ADDENDUM #1

CITY OF LAFAYETTE

**Mount Diablo Boulevard West End Pavement Preservation Project
Project Number 014-9699**

SP30-02 MATERIAL

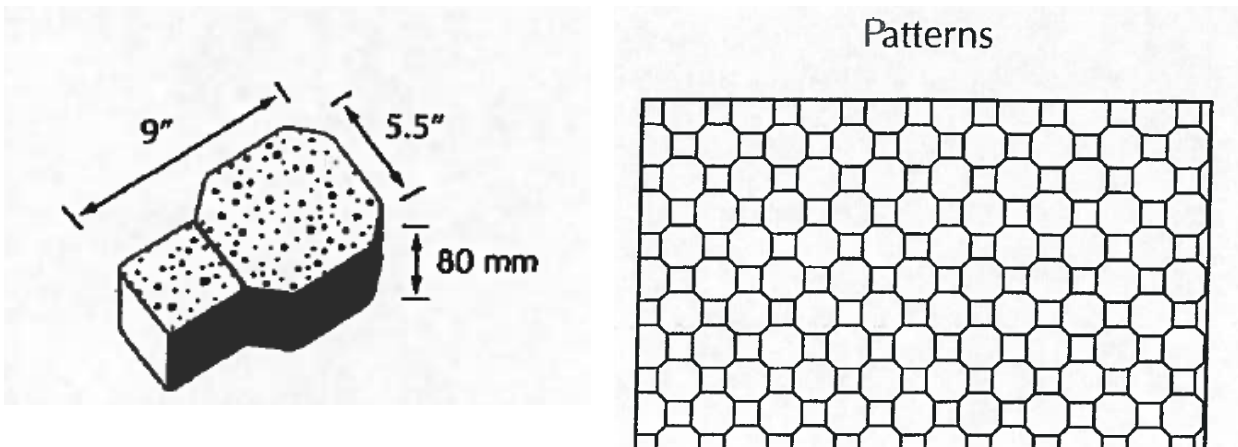
The first paragraph shall be replaced with the following:

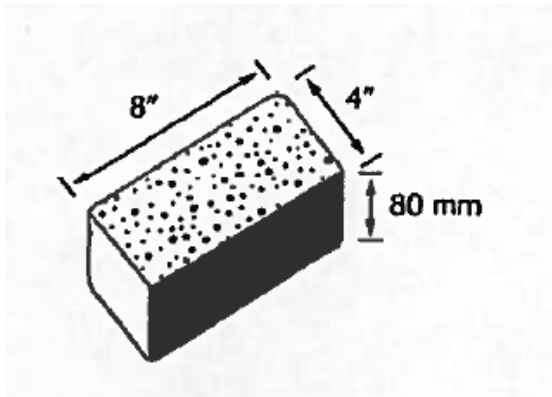
Newly constructed brick paver surfaces shall be constructed using interlocking pavers. Interlocking pavers shall have the following dimensions and shall be installed per the following pattern:
